**Technical Service Bulletin – TSB037**

***Helm MKII Air Piston Update***

Rev01 – 6/29/2020

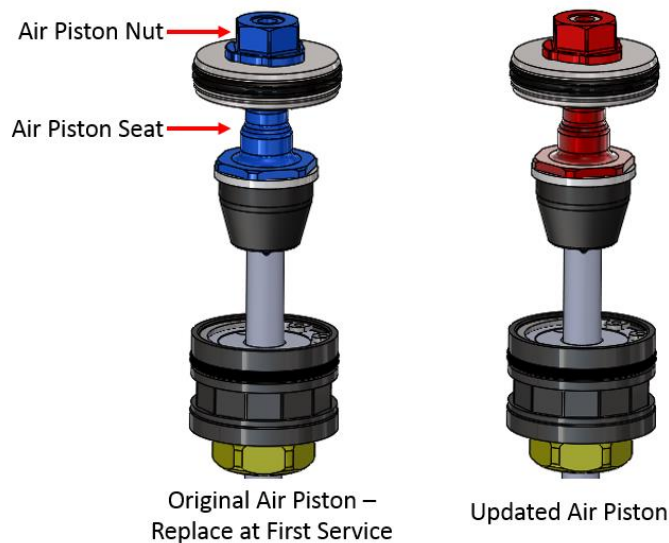
Blue Helm MKII Air Piston Seats have threads that risk breaking if the mating nut gets over torqued. A new, red, air piston seat with a larger thread diameter was implemented. This allows the air spring assembly to be torqued to the shaft through the 13mm top nut.

This change will be necessary at first service on all HELM MKII forks built between 6/1/2020 and 6/30/2020- approximately 80 units. The affected units are identifiable by having a blue piston seat and nut.

At first service, if the air piston assembly is blue discard it and replace with the red air piston assembly Cane Creek Kit – BAG0634.
